SUPPLEMENT NO. 1

SAFEGUARDS REPORT  
FOR THE SAXTON REACTOR PARTIAL  
PLUTONIUM CORE II

May 1965

Figure 7-1  
Vapor Pressure of Uranium  
and Plutonium Dioxides  
vs  
Temperature

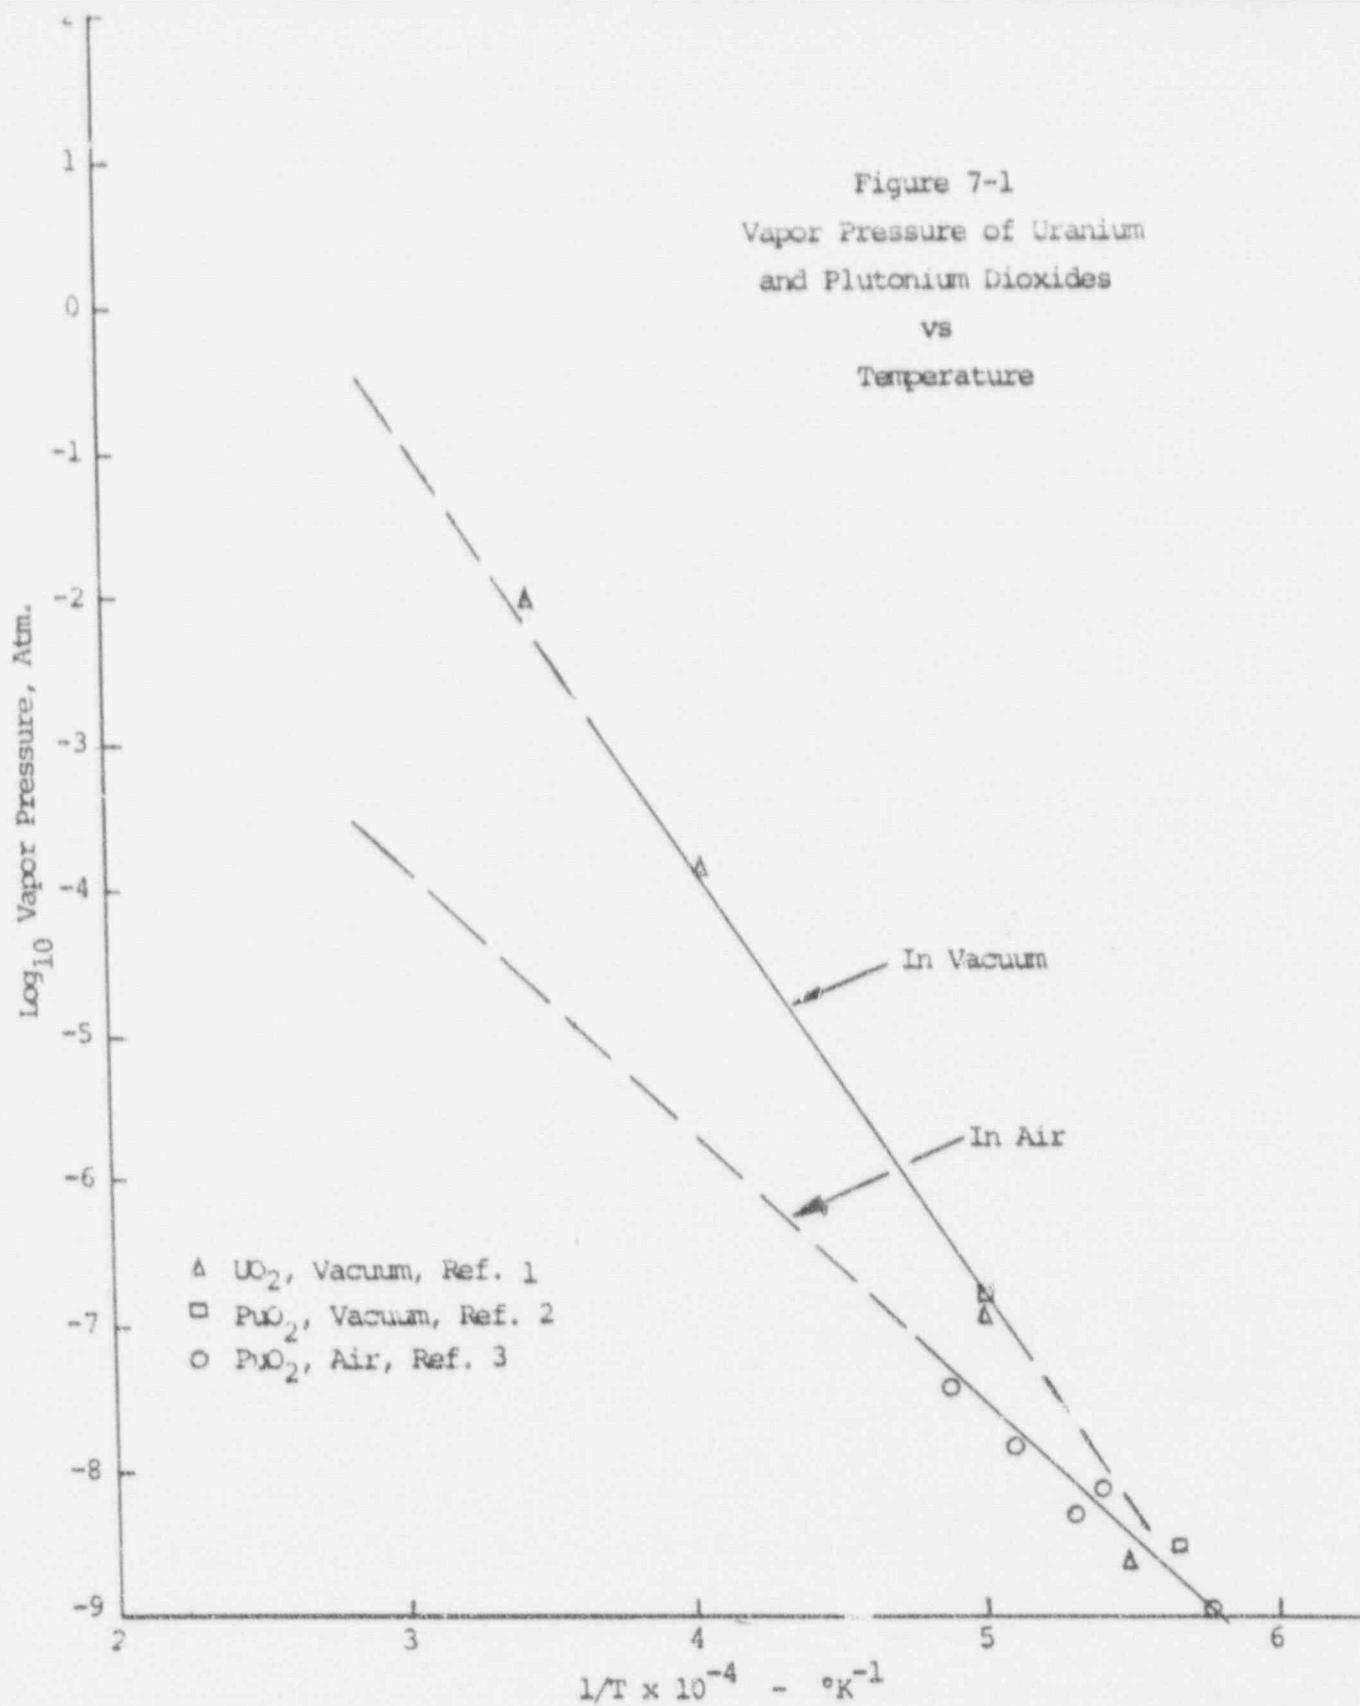
Question #7 - Provide an estimate of the amount of plutonium that might be released to the containment in the event of the "maximum hypothetical accident" to enable a more definitive evaluation of the consequences of this accident. In addition, provide an evaluation of the amount of plutonium that might subsequently reach the environs.

As shown in Figure 7-1, experimental evidence<sup>(1,2)</sup> indicates that the vapor pressures of plutonium dioxide and uranium dioxide follow the same curve as a function of the reciprocal of the absolute temperature as measured in a vacuum. Also shown on this figure are the experimental data<sup>(3)</sup> for the vapor pressure of  $\text{PuO}_2$  in an air atmosphere. As would be expected, the presence of an air atmosphere reduces the vapor pressure below that measured in a vacuum. For this calculation, it will be assumed that  $\text{PuO}_2$  and  $\text{UO}_2$  have the same vapor pressure - temperature relationship in an air atmosphere.
